Premium Quality Oil Seals

Models: All

No.: 20 (Rev. 1)

Date: July, 1983

## **Incorrect Pattern - Adjust Pinion Position**

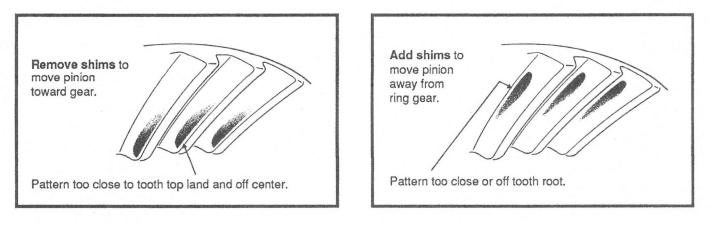
If the gear pattern shows incorrect tooth depth contact, change drive pinion position by altering the shim pack. Used gears should achieve proper contact with the same shims removed from the axle at disassembly.

**Note:** Check ring gear backlash after each shim change and adjust if necessary to maintain 0.008" to 0.018" (0.203 to 0.457 mm) backlash.

# **Standard Pattern**

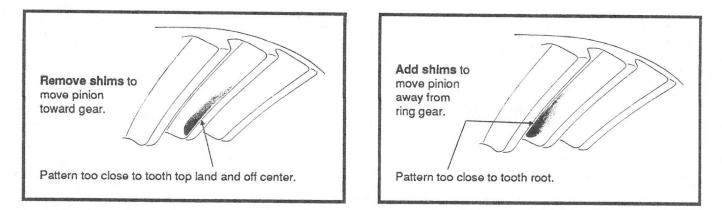
If the contact pattern shows incorrect tooth depth contact, change drive pinion position by altering the shim pack. Used gears should achieve proper contact with the same shims removed from the axle at disassembly.

**Note:** Check ring gear backlash after each shim change and adjust if necessary to maintain correct backlash (see appropriate service manual). Always recheck tooth contact pattern after making shim pack changes.
